AGENDA
Planning and Zoning Commission
January 18, 2023 – REGULAR MEETING

ITEM P22-253: Development Plan for a new 3-story mixed use building at the properties addressed 245 and 265 N. Millward St. Continued to January 18, 2023 Planning Commission Meeting.

Meeting Date:	January 18, 2023	Meeting Title:	Planning Commission
Submitting Department:	Planning	Presenter:	Tyler Valentine
Agenda Item:	P22-269 & 278: Request for a Land Development Regulation (LDR) Text Amendment to Section 2.2.9 and fee waiver.	Public Comment:	Yes

Meeting Date:	January 18, 2023	Meeting Title:	Planning Commission
Submitting Department:	Planning Department	Presenter:	Tyler Valentine
Agenda Item:	P22-242 Development Plan for a future 2-lot subdivision of the property located at 180 Aspen Drive	Public Comment:	Yes

A2.00

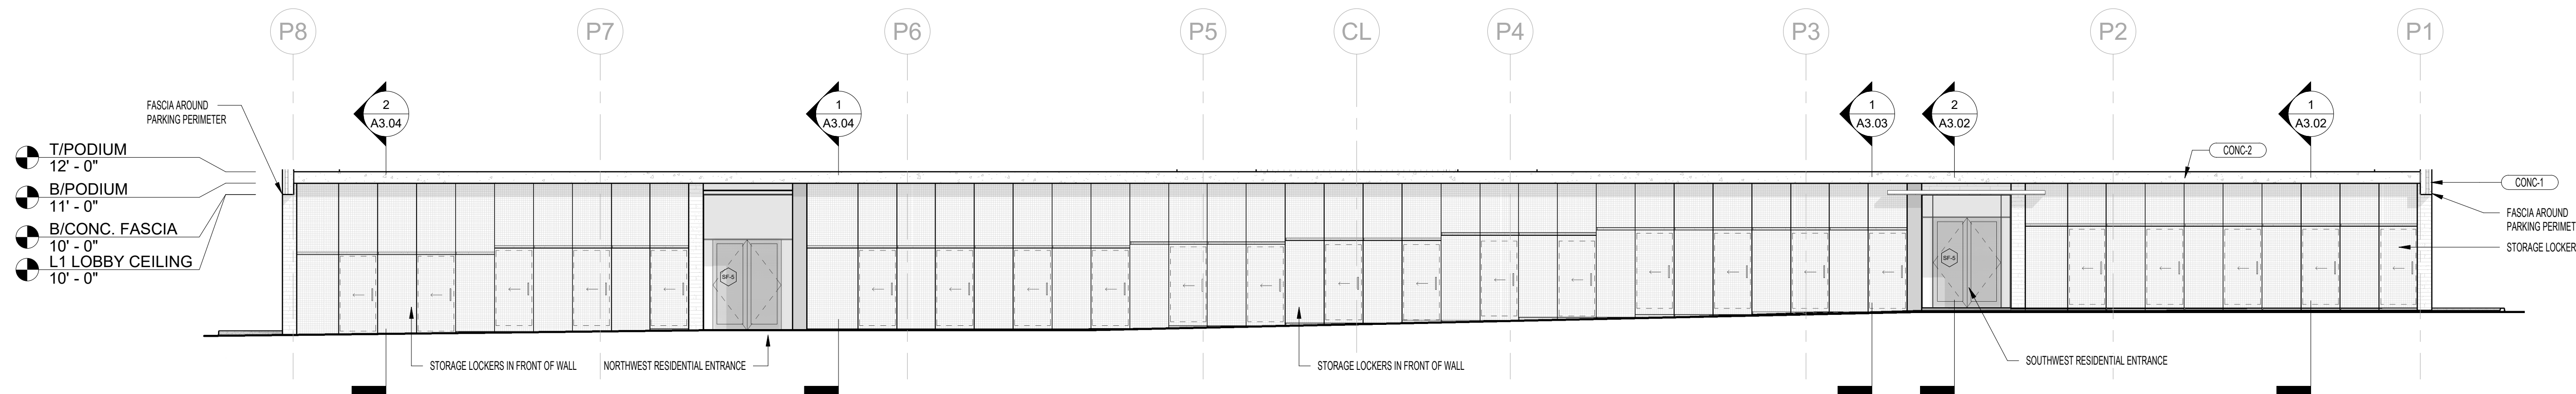
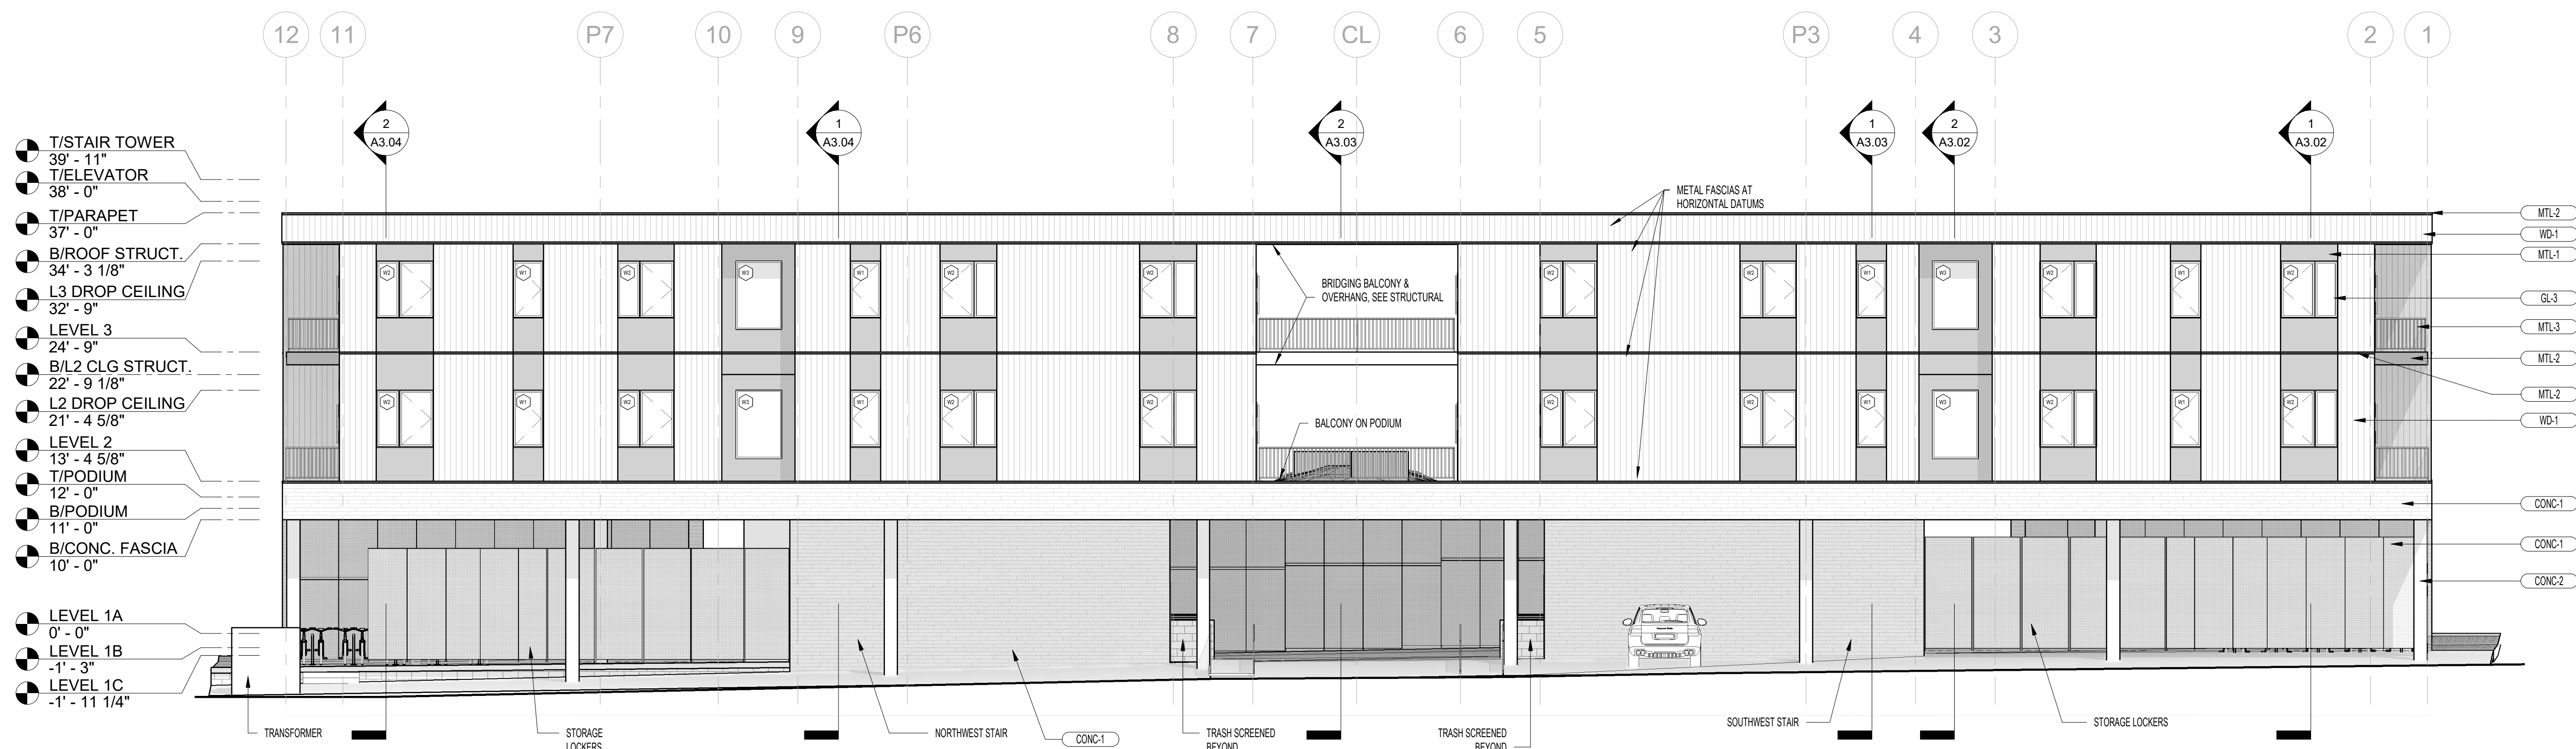
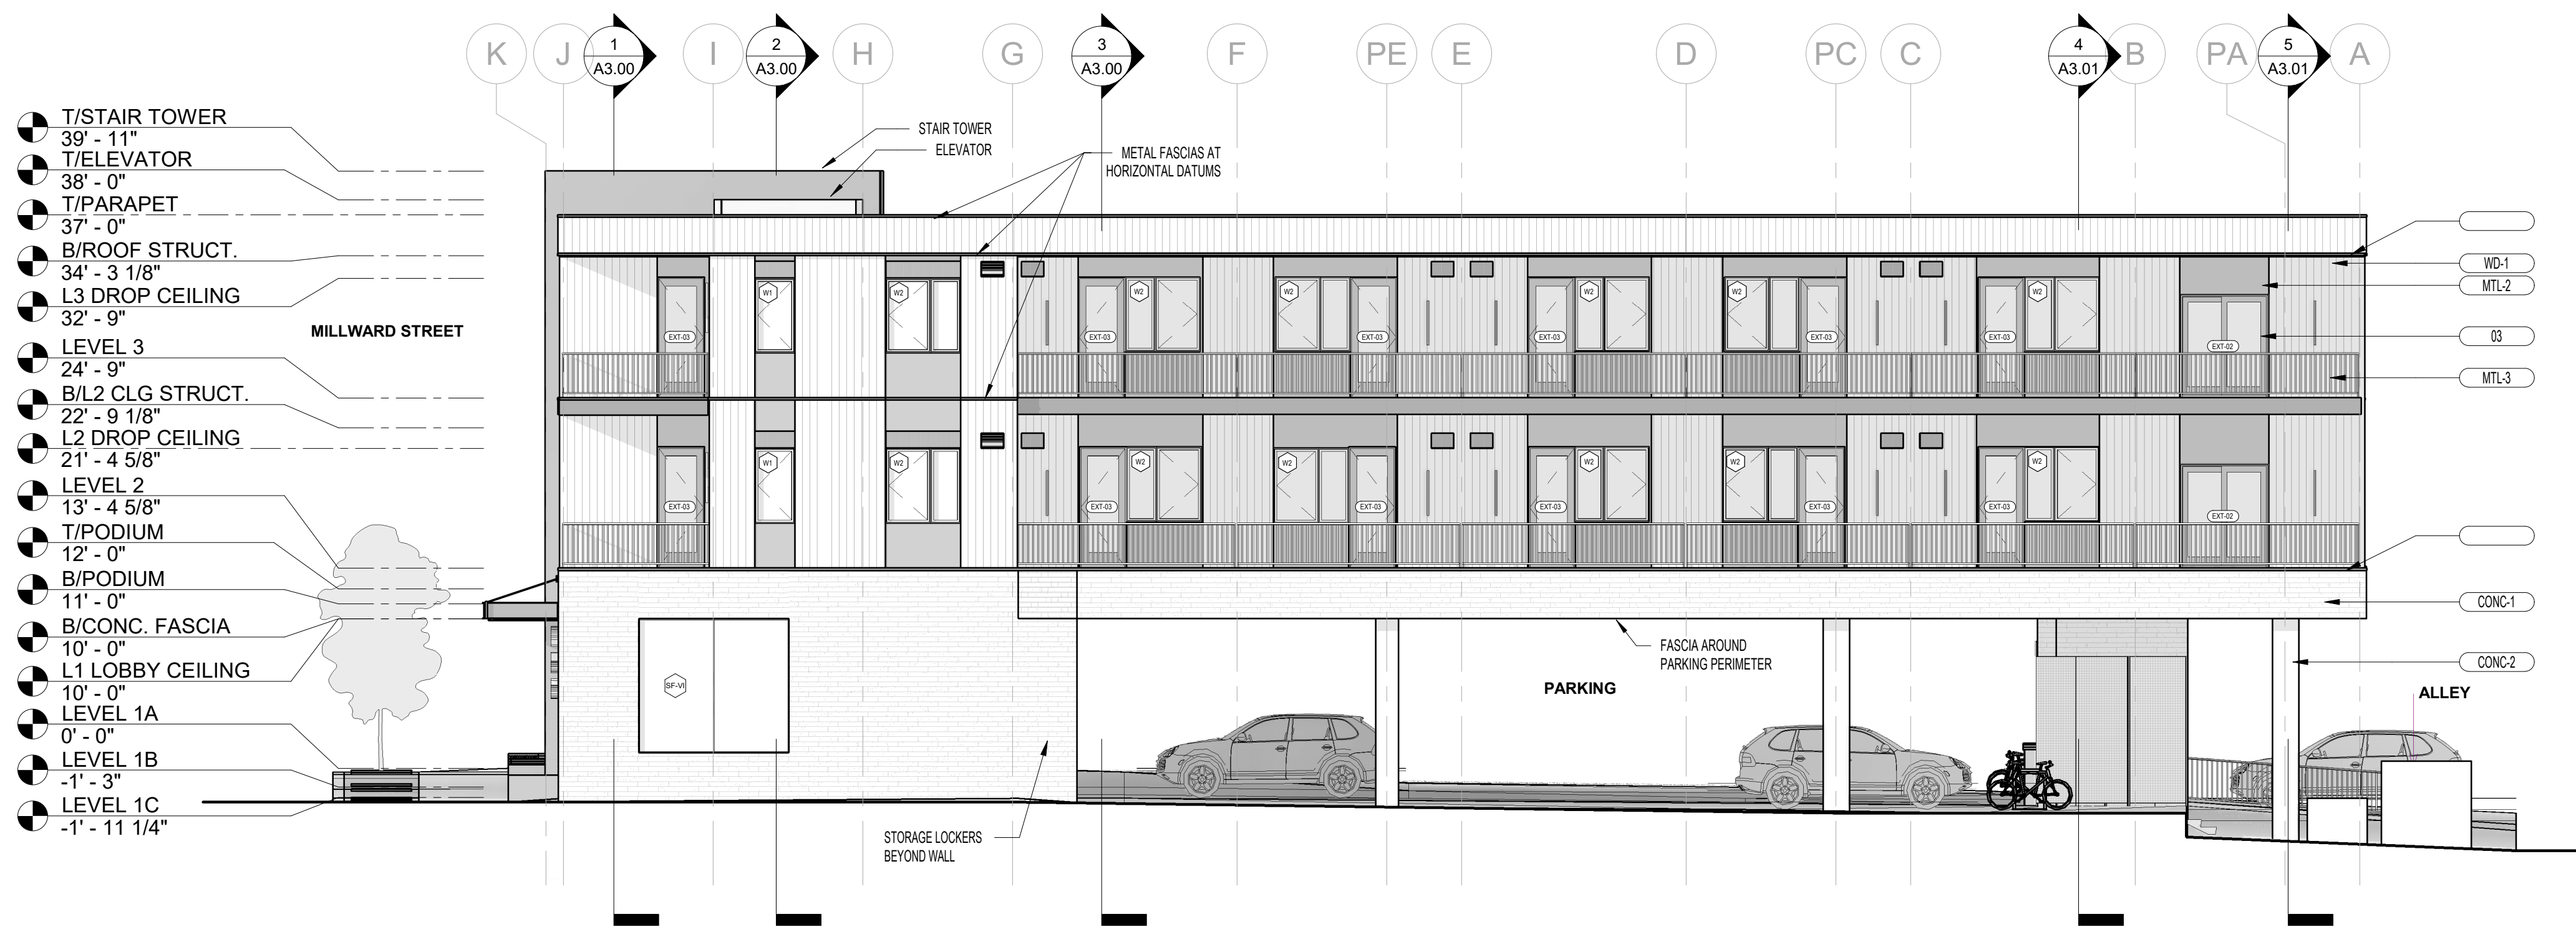
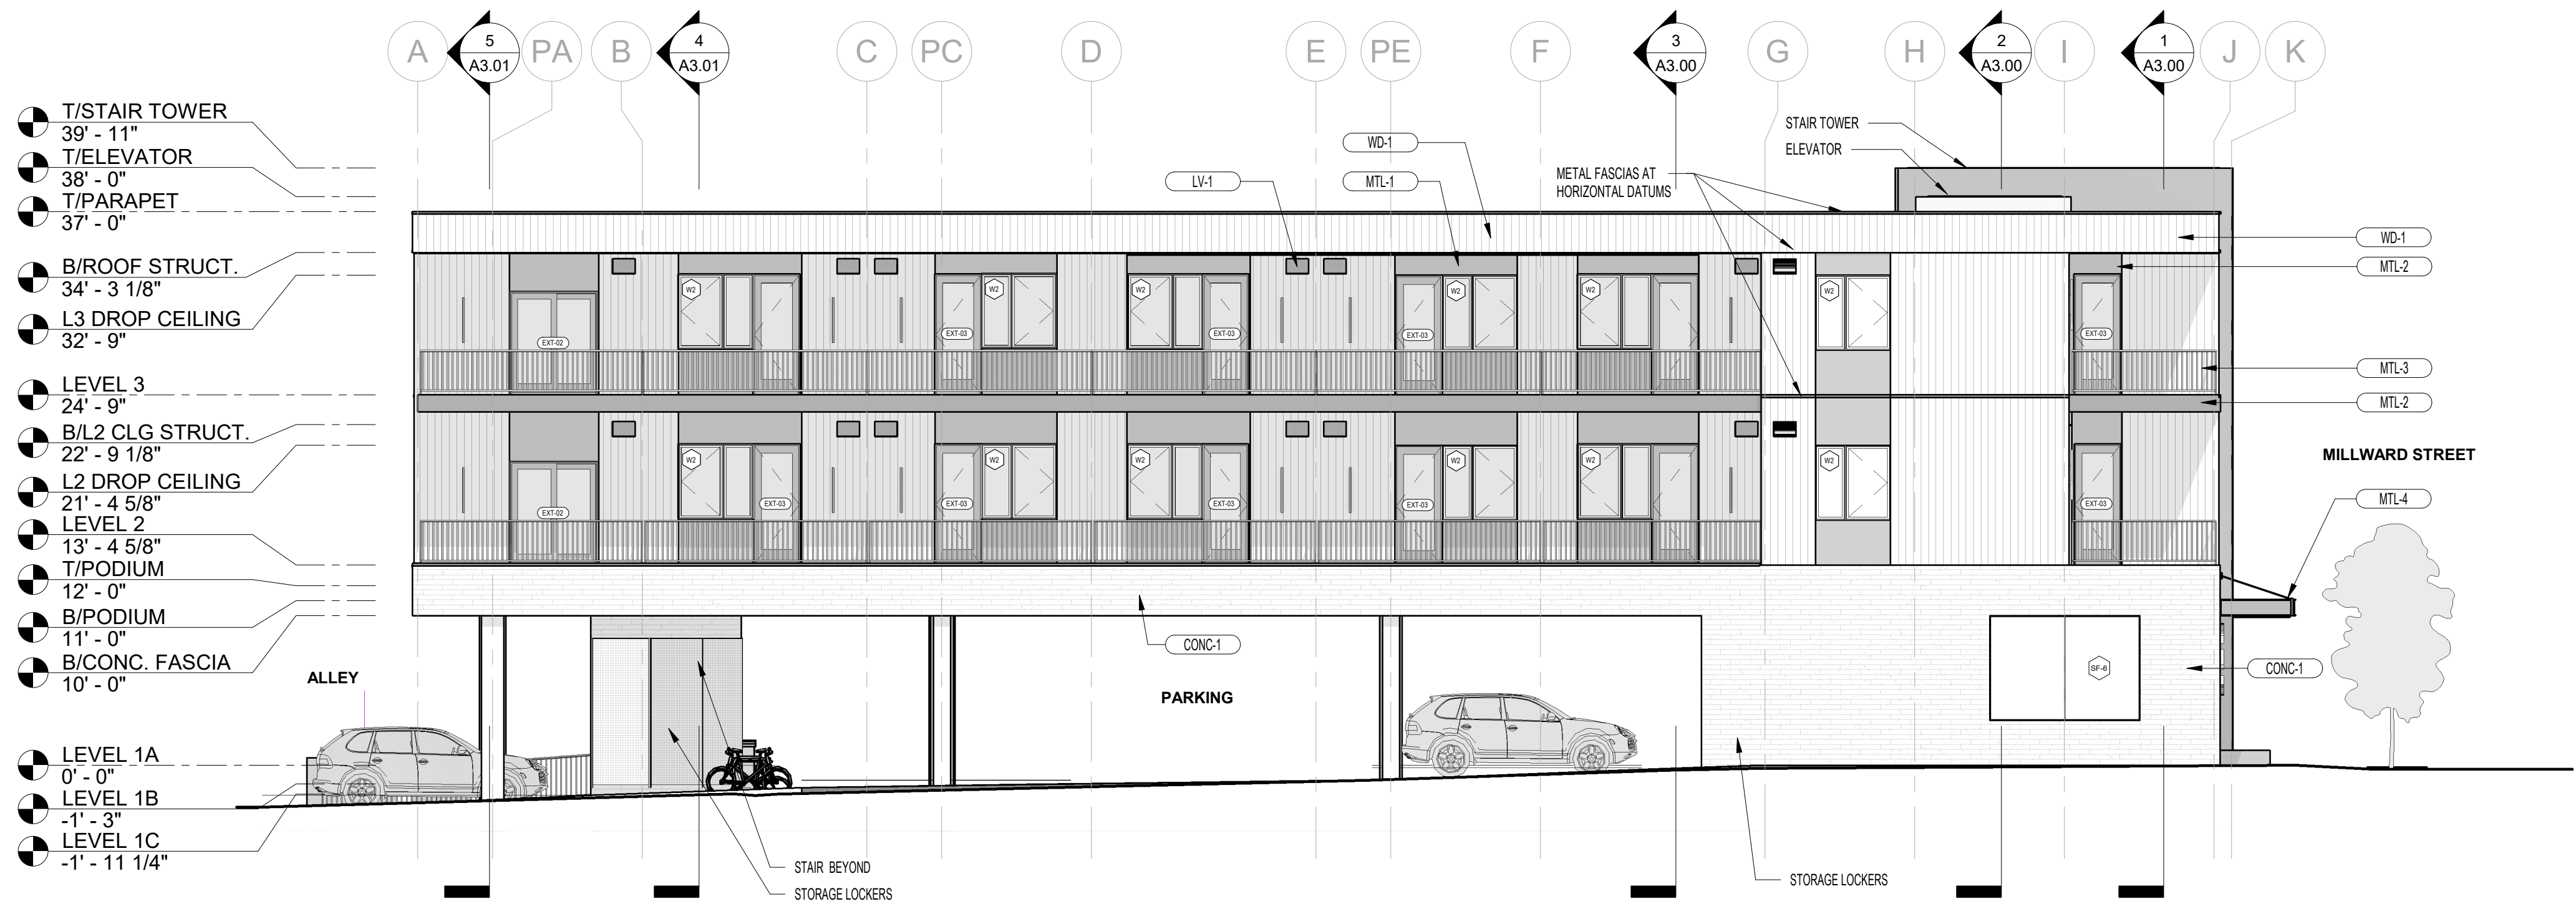
- Building Frontage (Shopfront vs. Office Frontage). Revise LDR compliance table to select only one (it is not tied to use) and to list subcategory compliance, specifically story height, transparency, blank walls, ped access. Revise elevations and floor plans to call out subcategory compliance (for frontage type) such as transparency requirements. May be similar to applicant providing stepback calcs on pg 37 of submittal packet. **Updated in LDR Compliance table and in architectural plans and elevations. See A2.00 for façade calculations.**
